**Subject:** Re: May 15th UDC Meeting - Agenda & Public Notice

Re: UDC 2025-11 Mayo Island Park

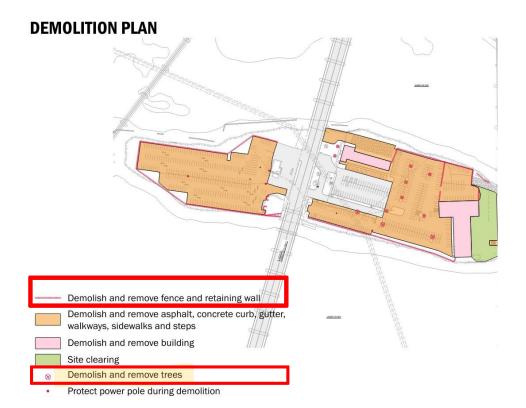
Please distribute my comment below to the UDC members regarding UDC 2025-11 Mayo Island Park on the May 15, 2025 agenda:

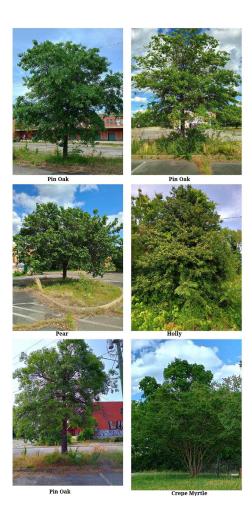
If I could please make two suggestions regarding the "Demolition Plan" of the existing facilities on the portion of the park on the east side of the Mayo Bridge:

1). Please consider saving some of the trees that are slated for removal under the Demolition Plan. Many of the trees are healthy and will provide much needed shade. The majority of the trees noted for removal are pin oaks, and there are two large holly trees, along with a couple of pear and crepe myrtle trees. The photographs below were taken of some of the trees that were marked on the plan for removal that should be maintained for shade:
